RE: Notice Pursuant to 49 CFR Sec. 573.5

SKF USA Inc. ("SKF") has determined that a defect which relates to motor vehicle safety exists in an item of motor vehicle equipment manufactured by SKF at its Glasgow, KY plant. The item of equipment that is of concern is a hub unit that is more particularly described below.

The item of equipment that contains the safety related defect is identified by SKF as its part number BR930361 (the "Hub Unit"). The applications for the Hub Unit are: The front axles of the Dodge Durango, model years 1999-2003, equipped with 2-wheel drive, rear wheel ABS; and the Dodge Dakota, model years 1997-2004, also equipped with 2-wheel drive, rear wheel ABS. The Hub Unit was a new product in that it was not manufactured by SKF prior to its initial production by SKF at its Glasgow, Kentucky plant. Production of the Hub Unit commenced in April, 2008. SKF did not supply the Hub Unit to any vehicle or other manufacturer, but sold the Hub Unit as a service part into the vehicle service market starting in June, 2008.

EXHIBIT II

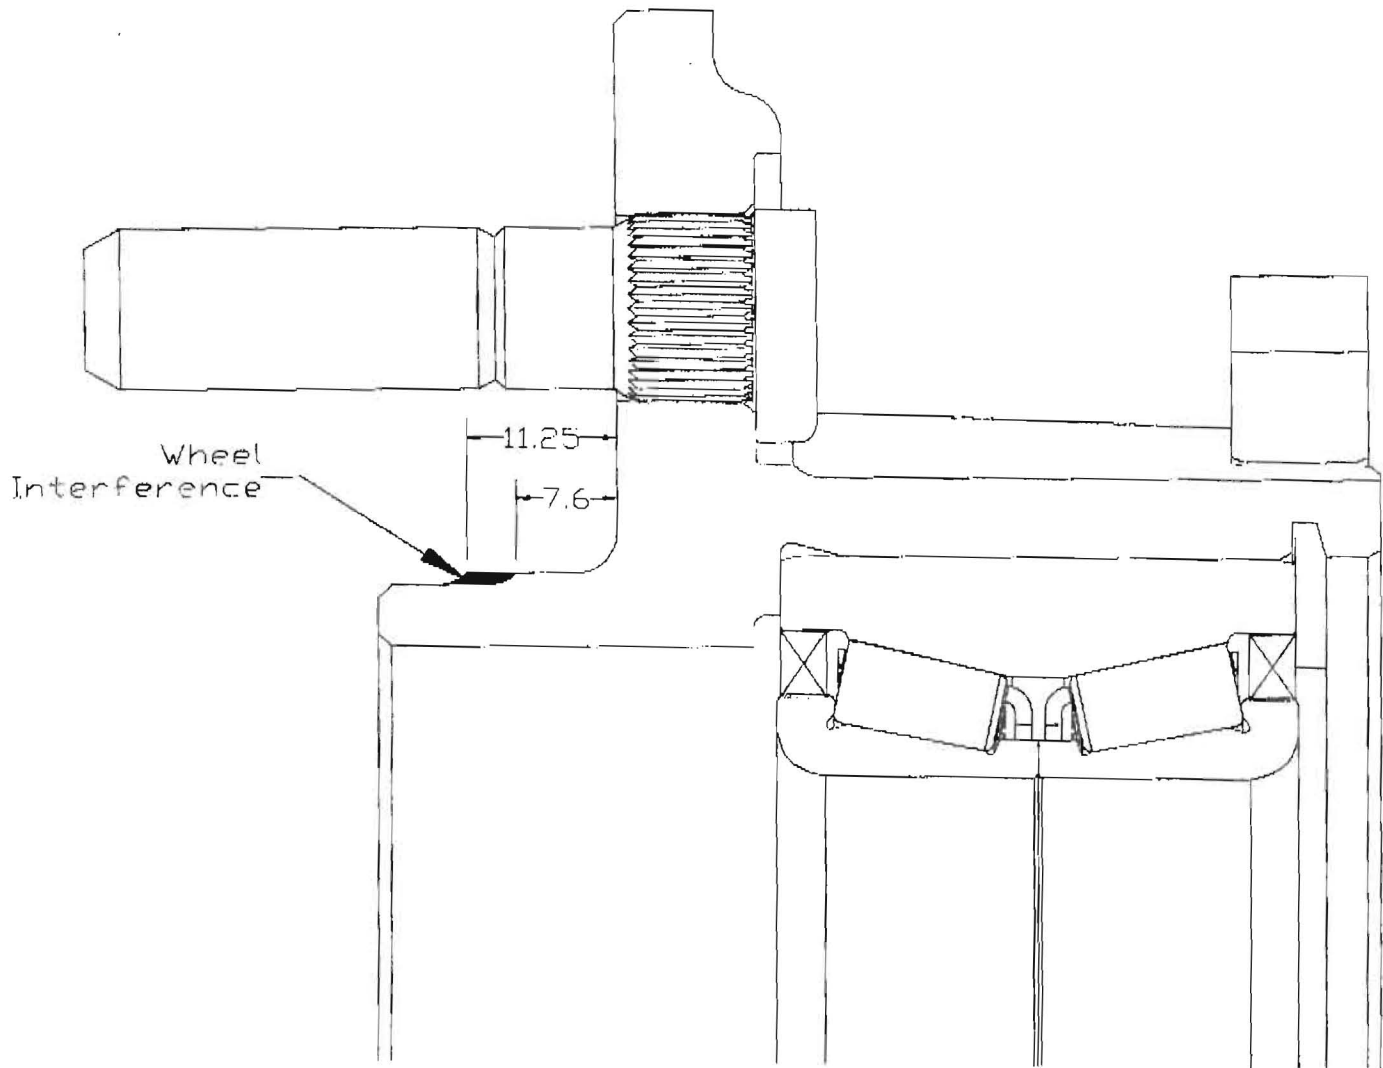
The defect resulted from an error in a specification for the length of the rotor pilot for the Hub Unit. The error was contained in a manufacturing product drawing provided to SKF's Glasgow, Kentucky plant to manufacture the Hub Units. The specification indicated in the drawing was too long. The dimension specified was 11.25 mm. The correct dimension is 7.6 mm. This results in the wheel not seating fully against the hub

flange face during mounting. The error in specifying the length of the rotor pilot resulted in excess material remaining on the rotor pilot which prevents the wheel from fully seating against the hub flange face. Exhibit II attached to this notice indicates the location of the defect.

September 24, 2008: The manufacturing product design drawing for the Hub Unit is corrected.

SKF proposes to replace, at its expense, all the Hub Units in the suspect population of parts manufactured at its Glasgow, Kentucky plant. SKF has 4,000 pieces of correctly finished Hub Units in stock at its Glasgow plant which can be used to support the recall. The specifics of the recall program to affect a remedy are yet to be determined by SKF.
